JOB 090580
ARKANSAS WELCOME CENTER (I-49) (S)
JULY 31, 2024

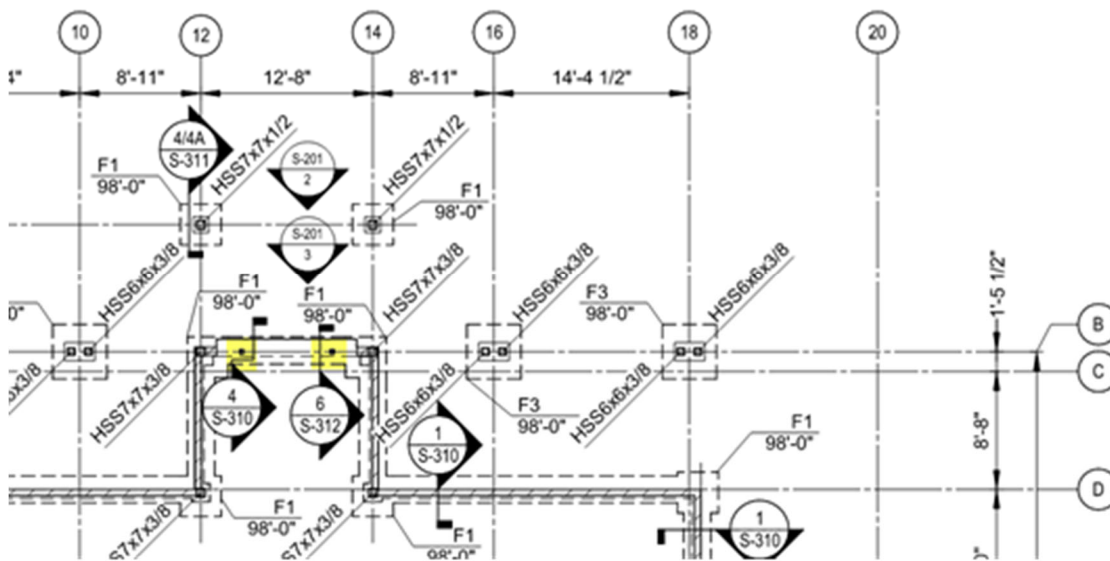
There are discrepancies between site demo, locations of existing trees to remain and locations of new landscaping. Please clarify where site demo and new work are to happen compared to "existing to remain" areas.

Tree removal limits shown on Demolition Plan (C-021 and C-022) are correct. New planting beds and trees are to be installed where shown on Landscape Plans (L-101 to L-104). All areas disturbed by construction are to be stabilized with sod. All other areas outside of the limits of construction are to remain untouched. The 6 Northern Red Oak Trees located near the detention pond will not be required.

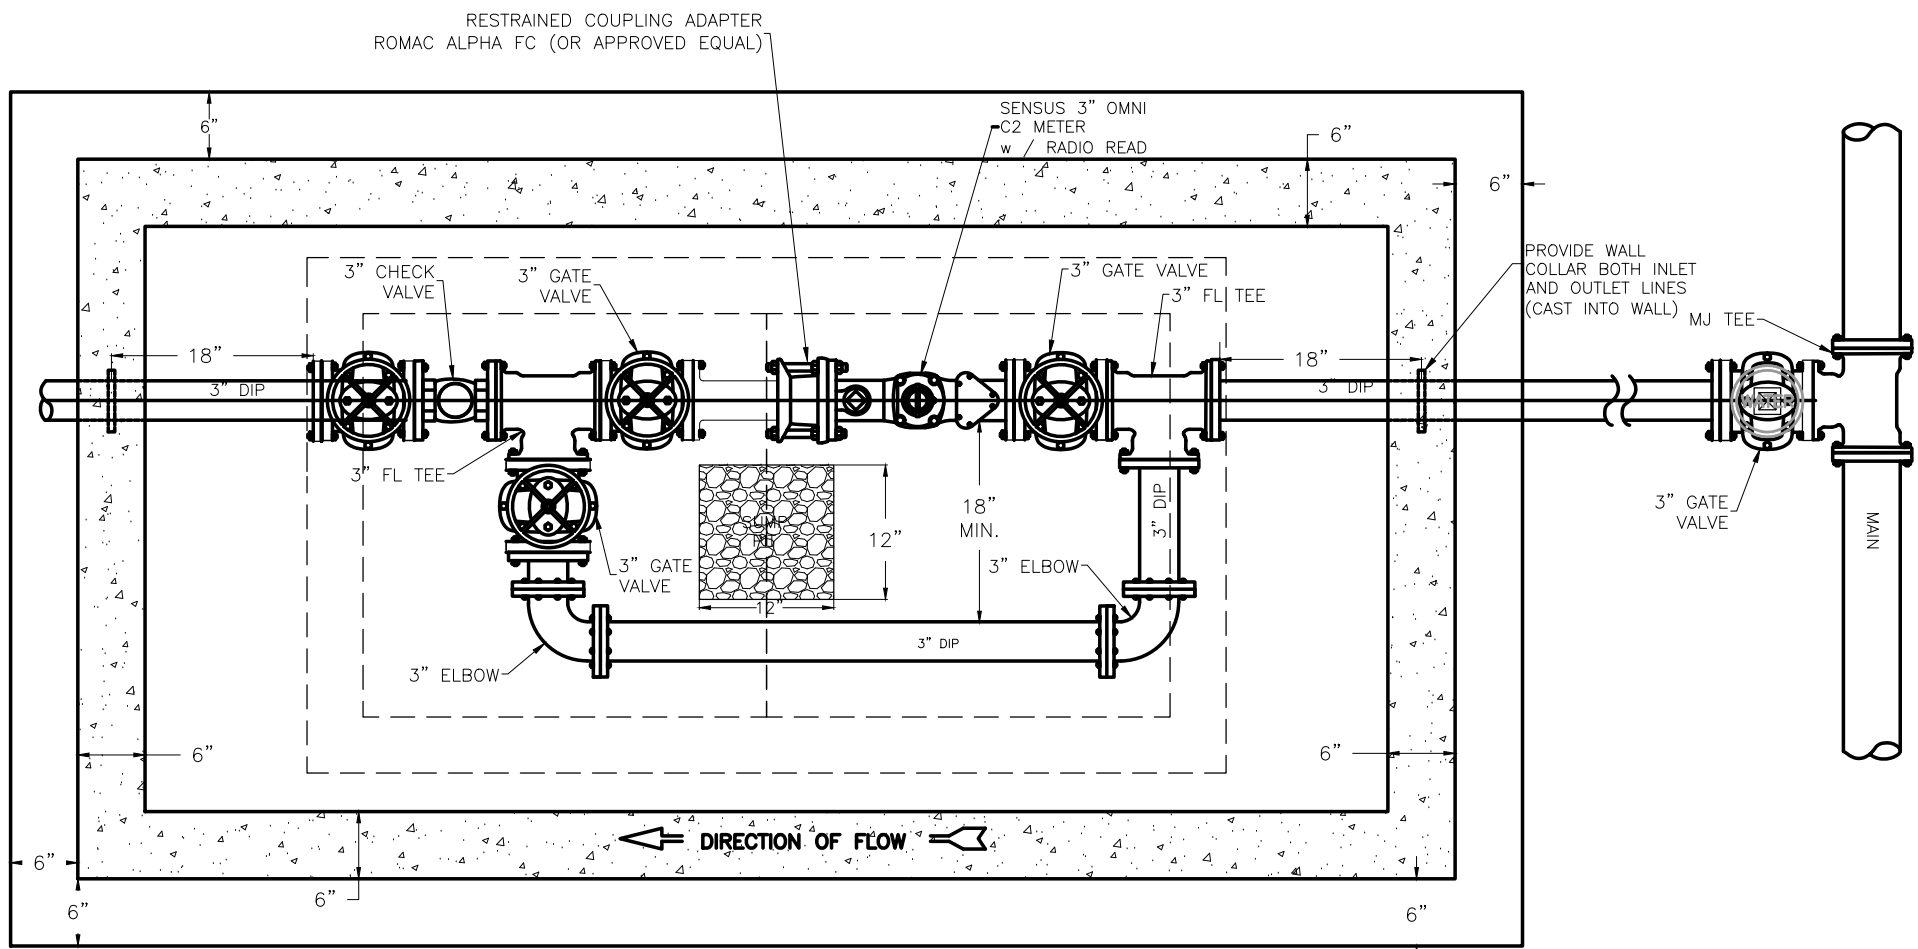
There are (4) 5x5x3/8, (12) 6x6x3/8, (4) 7x7x3/8 and (2) 7x7x1/2 HSS columns shown in plan view on S-101. Base plates types are shown and listed on S-501. Base plates for the 6x6x3/8 column are not listed but do list for a 3x3x3/8 which are only shown in section view 3 on S-201 but no plan views. Please confirm base plate type for the 6x6x3/8 columns. Please show locations for the 3x3x3/8 columns in plan view.

The HSS6x6x3/8 column base plates can be PL3/4"x12"x1'-0" square plates with (4) 3/4" diameter cast-in-place anchor rods with 0'-8" embedment. The anchor rod and base plate layout shall match Base Plate Type 1 on 1/S-501. The HSS3x3x3/8 columns are highlighted in the screenshot below. The columns and sizes are shown within the elevation on 3/S-201 as noted within the detail 6/S-312 found on plan at these columns.

**3-INCH METER VAULT
NTS**

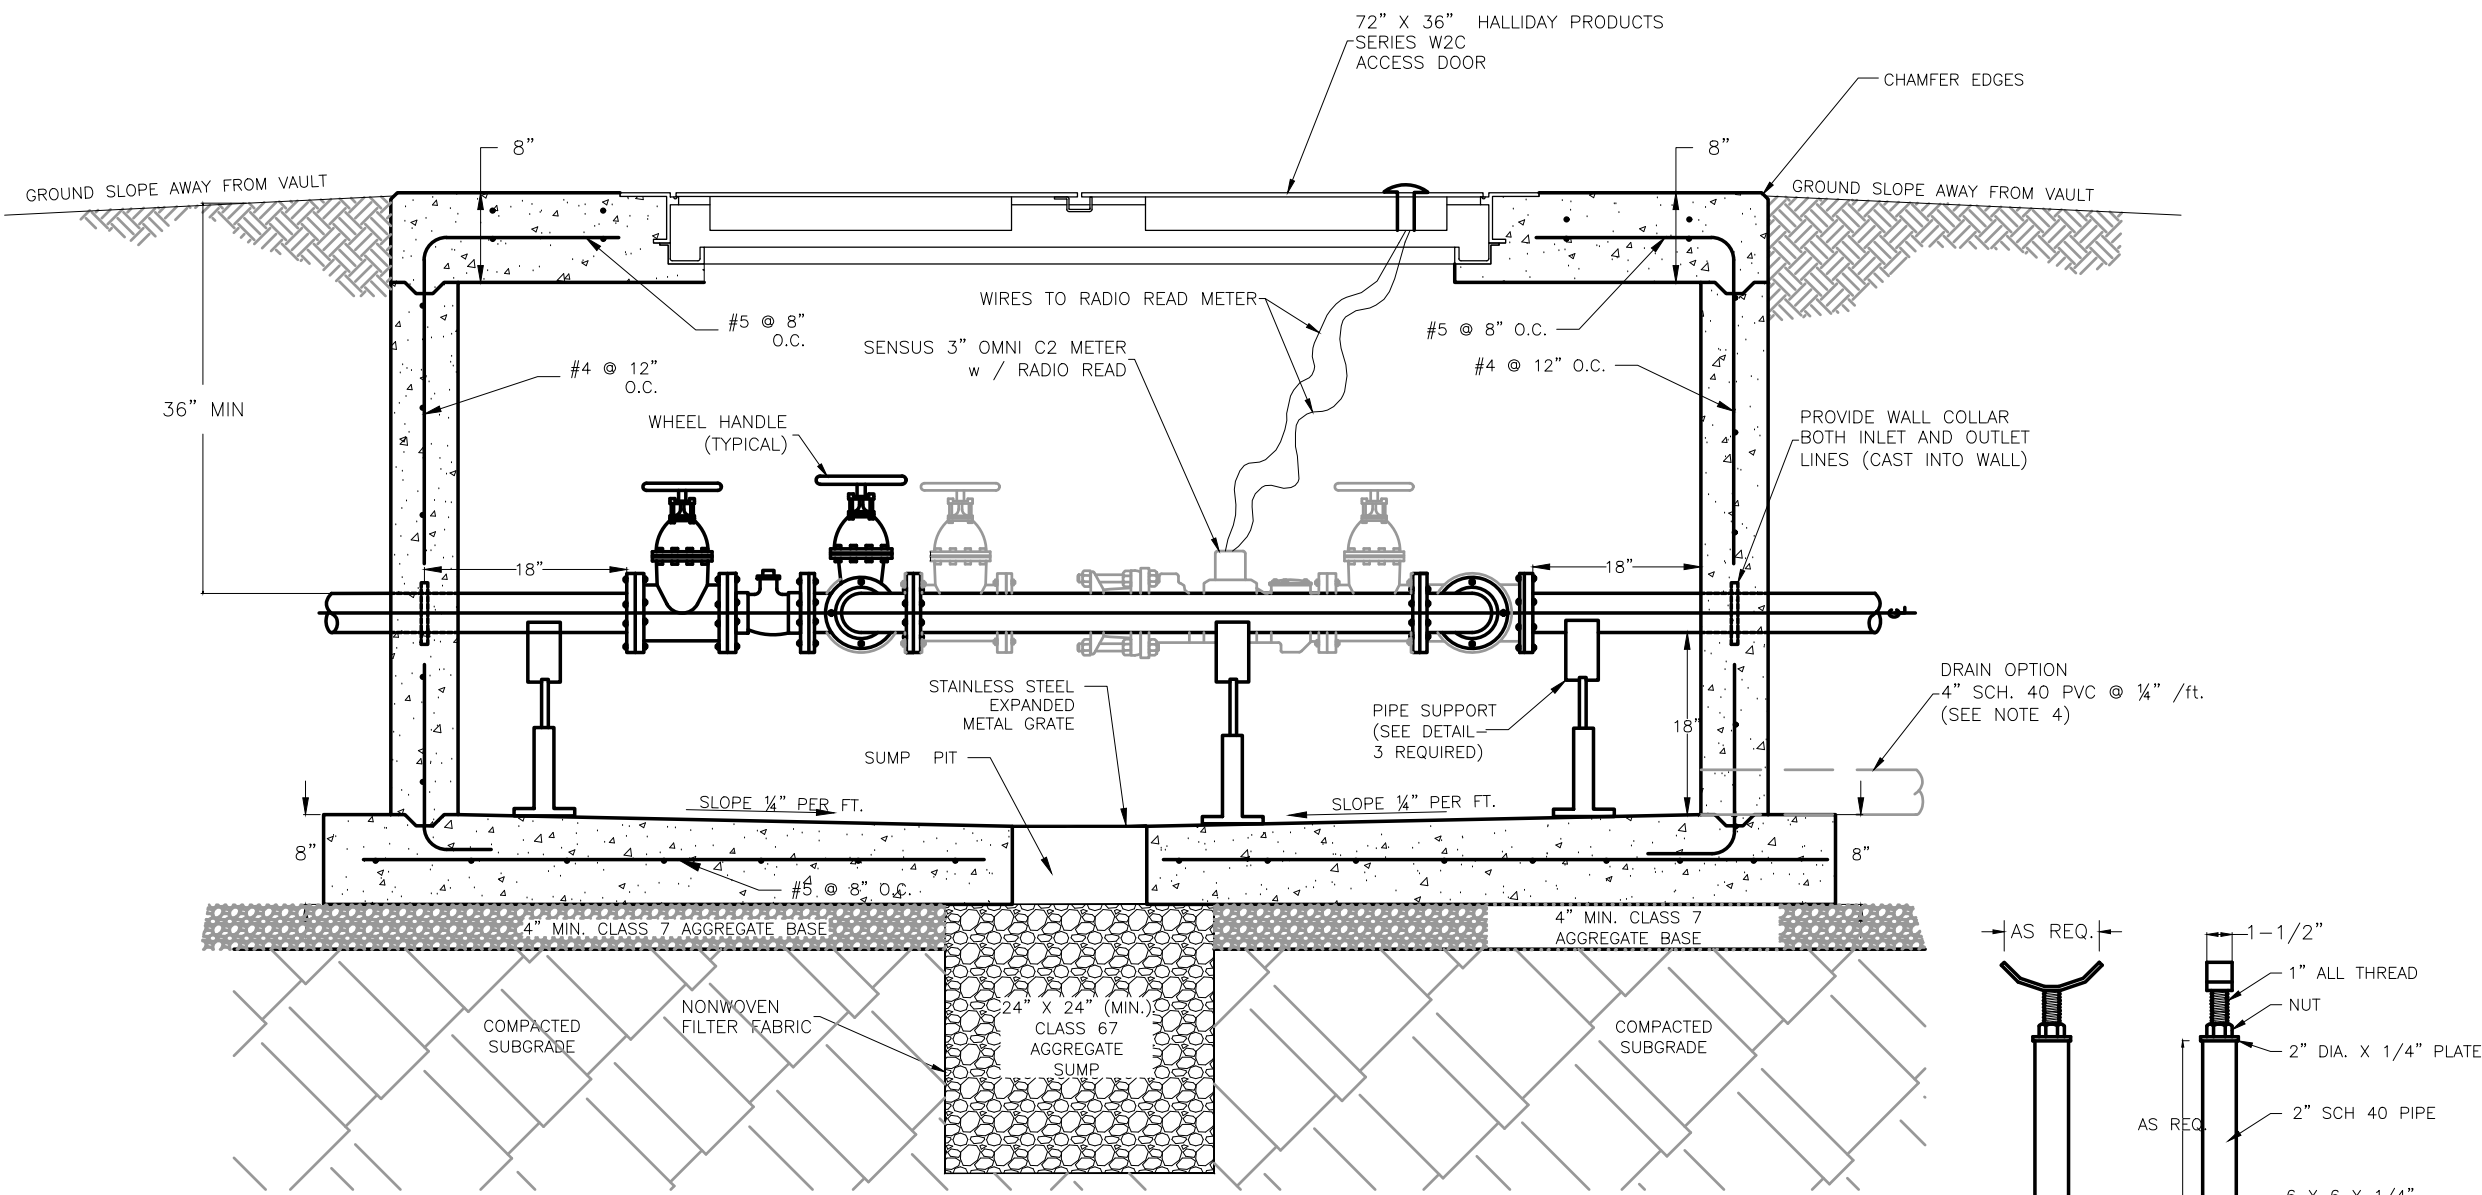
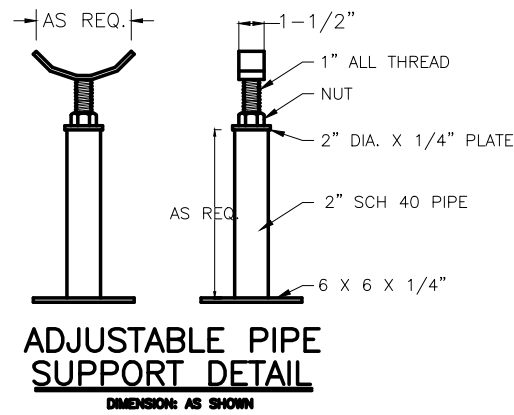
Can you request as a detail for the 3" water meters? These are typically in a vault and the Centerton Water Utilities does not have a standard detail in their specifications.

Please see the detail attached below.
